DESIGN REVIEW BOARD
1200 STEWART STREET
 EARLY DESIGN GUIDANCE

NOVEMBER 25, 2008
 DPD PROJECT 3007548

**SECTION
AT DENNY WAY**

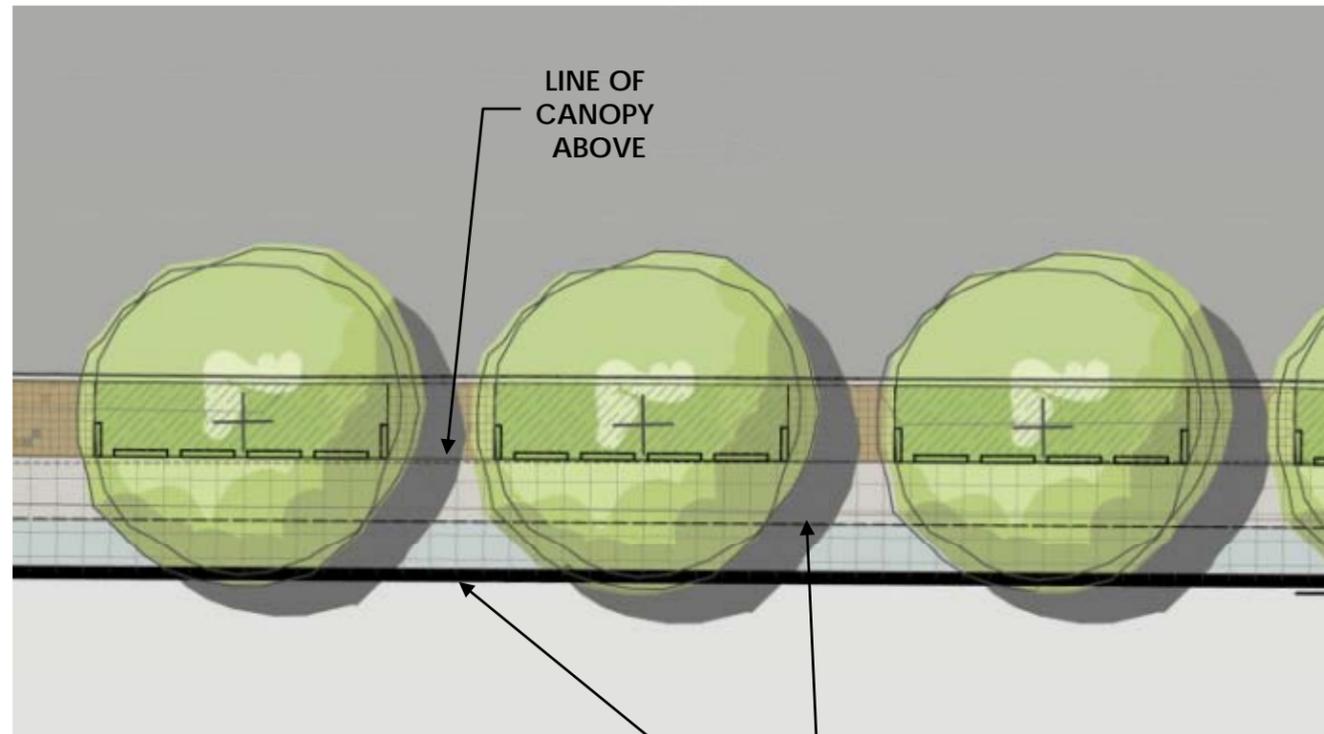
Provide detailed graphics of the pedestrian street experience, with and without landscaping. Include development of entries.

Response: Denny Way sidewalk has been widened to 15', incorporating a 6' wide planting strip and 9' walking path. Planting and street trees will enhance the pedestrian experience and buffer them from traffic. A canopy provides overhead weather protection.

EARLY DESIGN GUIDANCE RECOMMENDATION

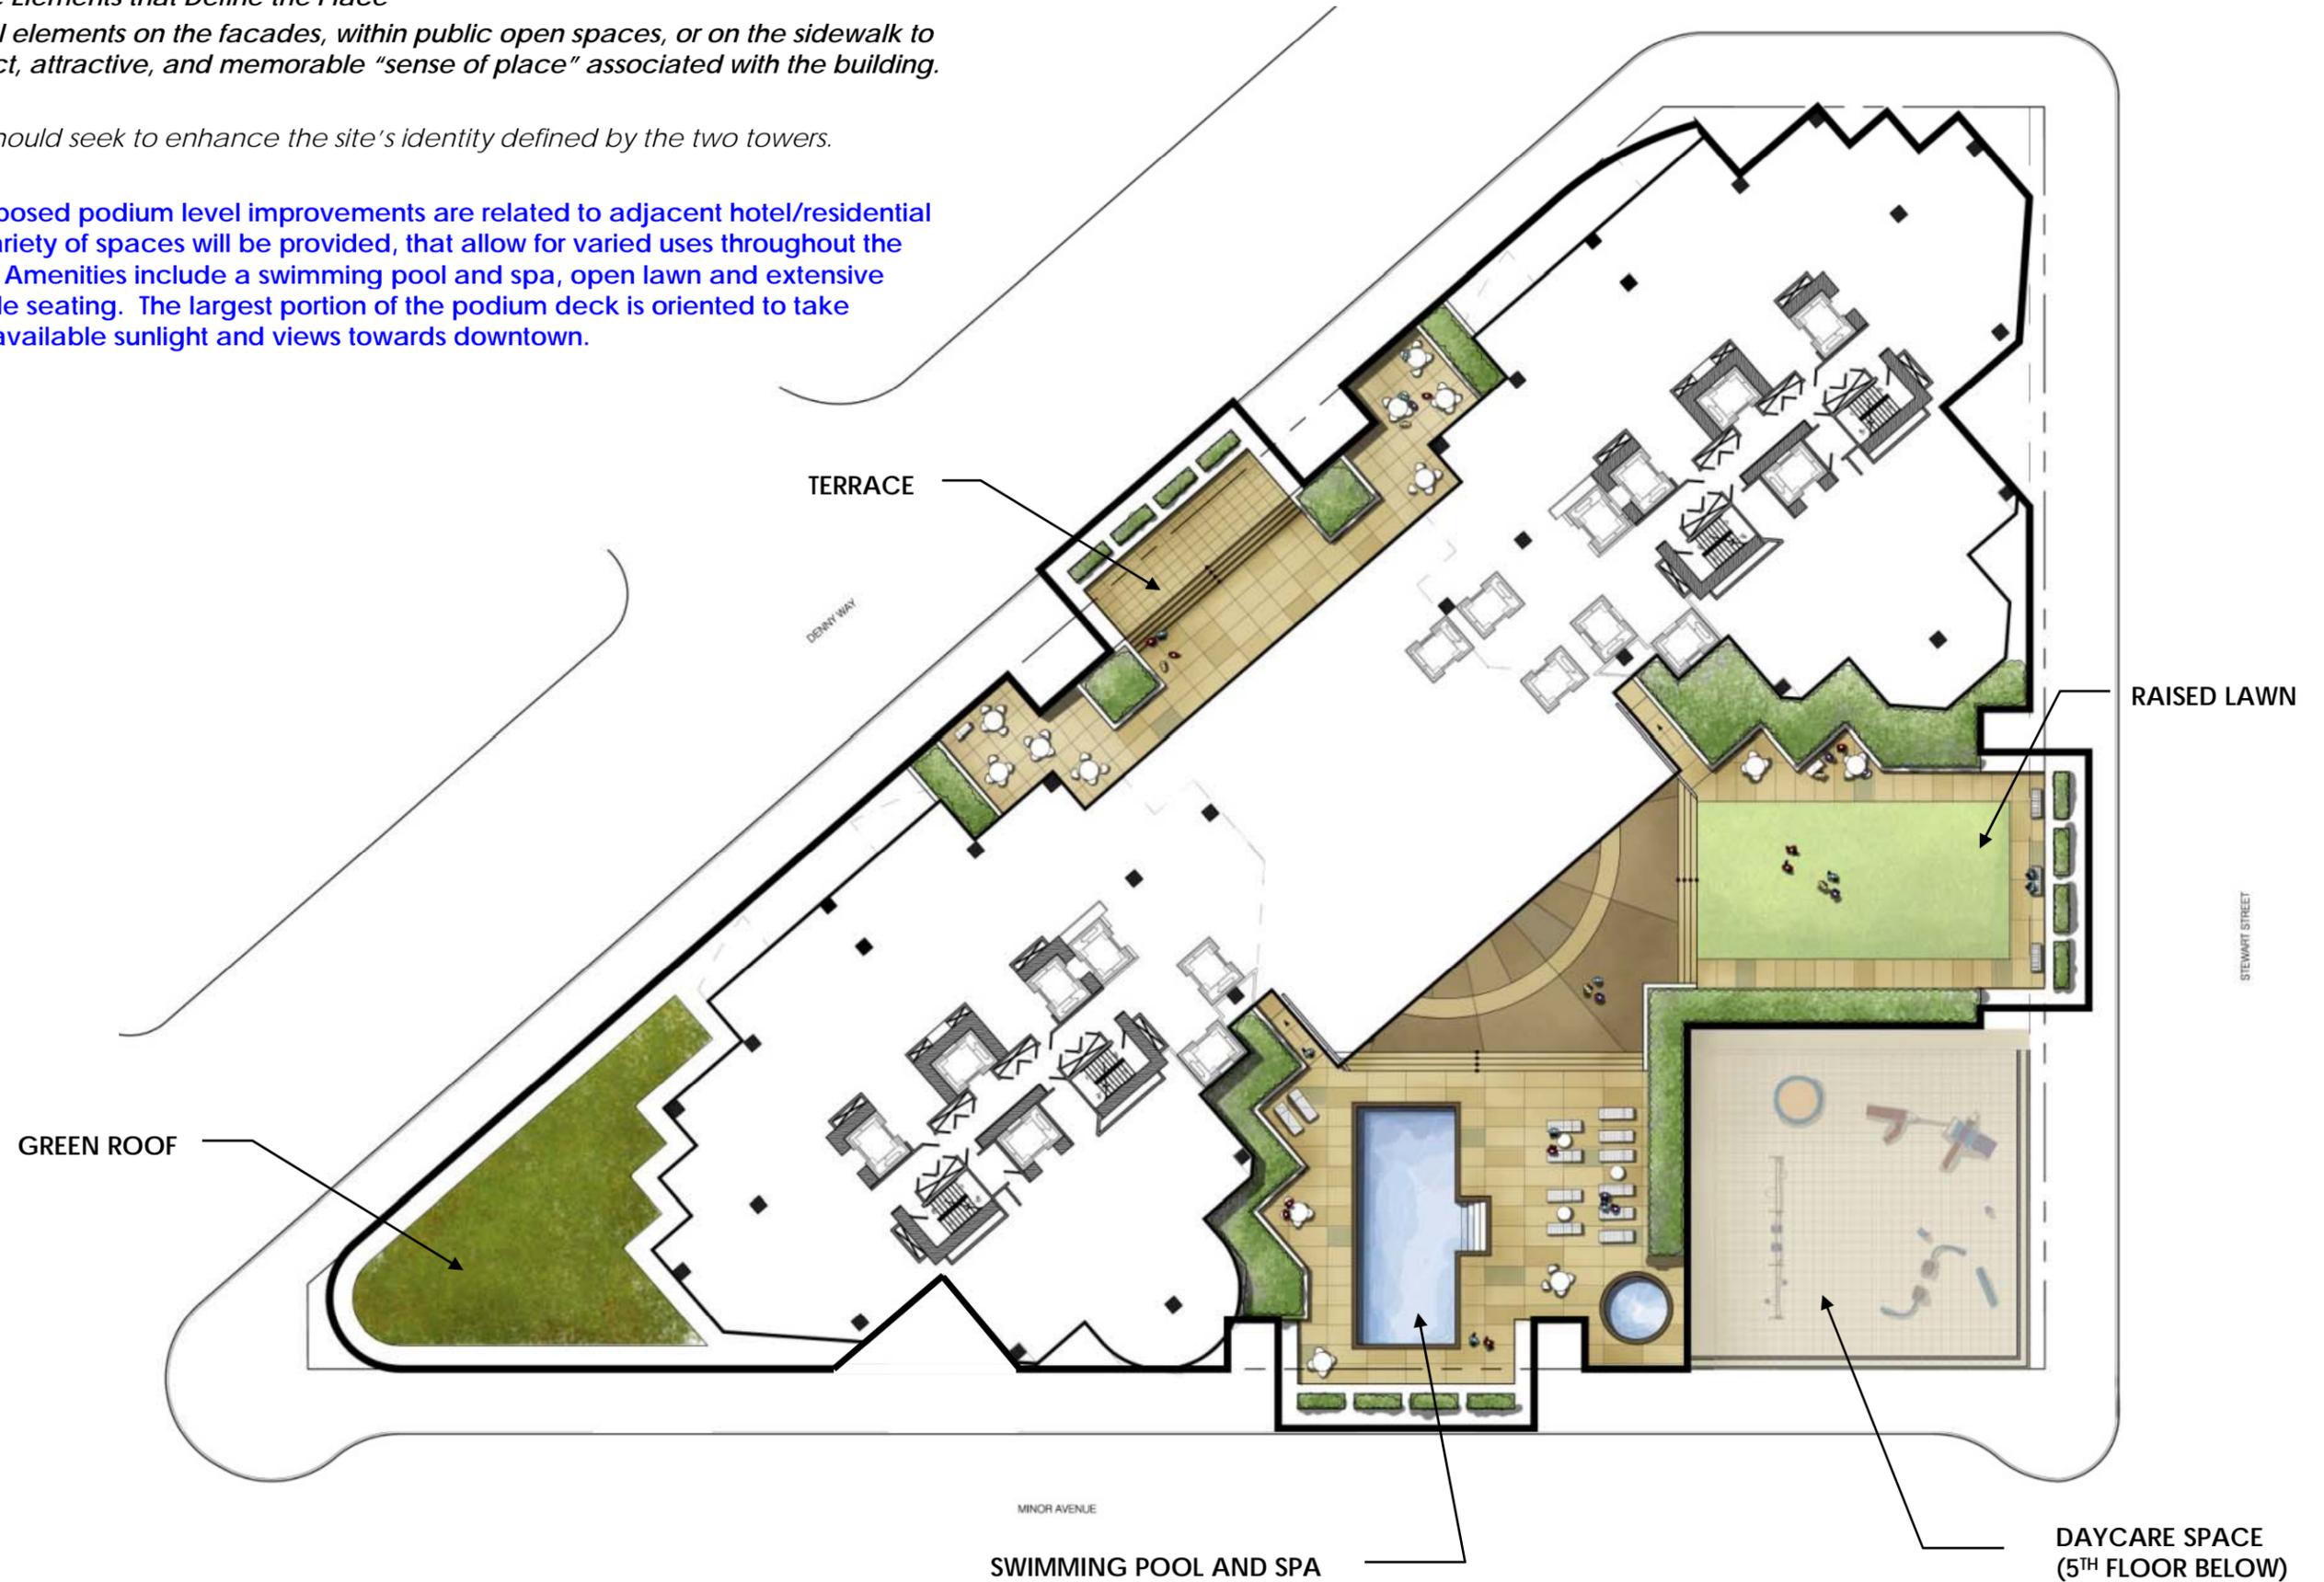
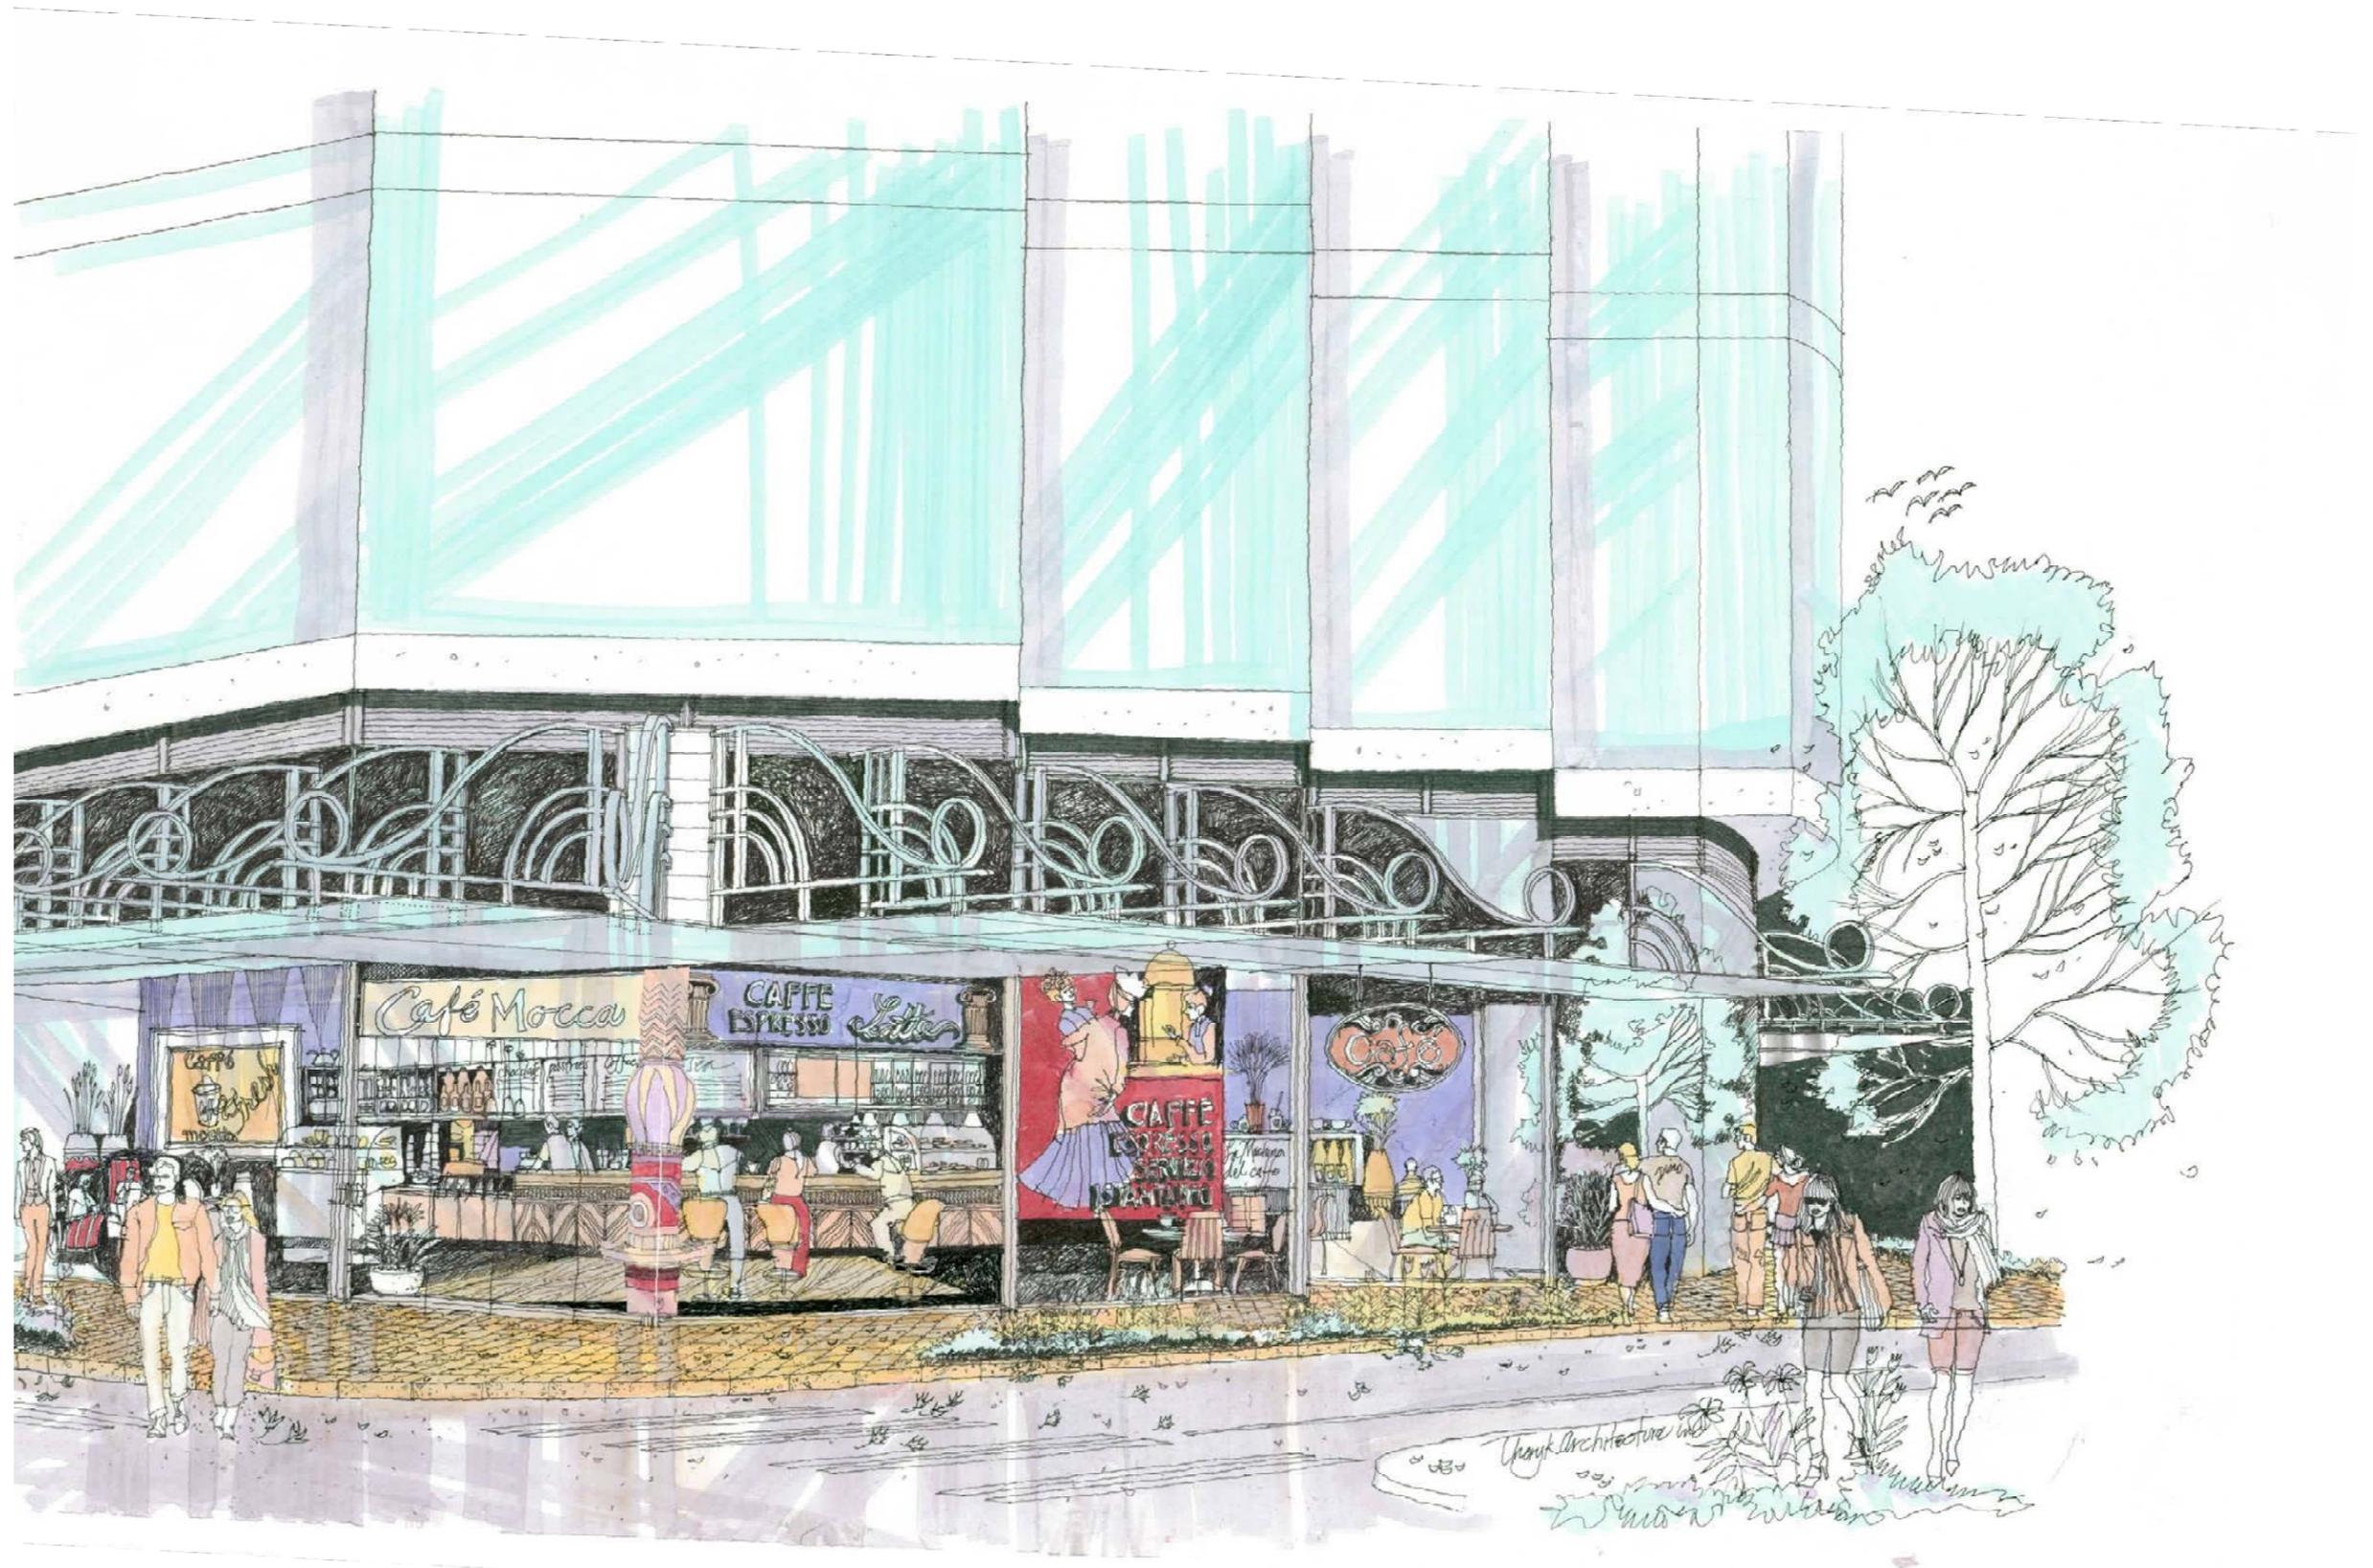
Podium level should seek to enhance the site's identity defined by the two towers.

Response: Proposed podium level improvements are related to adjacent hotel/residential functions. A variety of spaces will be provided, that allow for varied uses throughout the day and year. Amenities include a swimming pool and spa, open lawn and extensive areas for flexible seating. The largest portion of the podium deck is oriented to take advantage of available sunlight and views towards downtown.
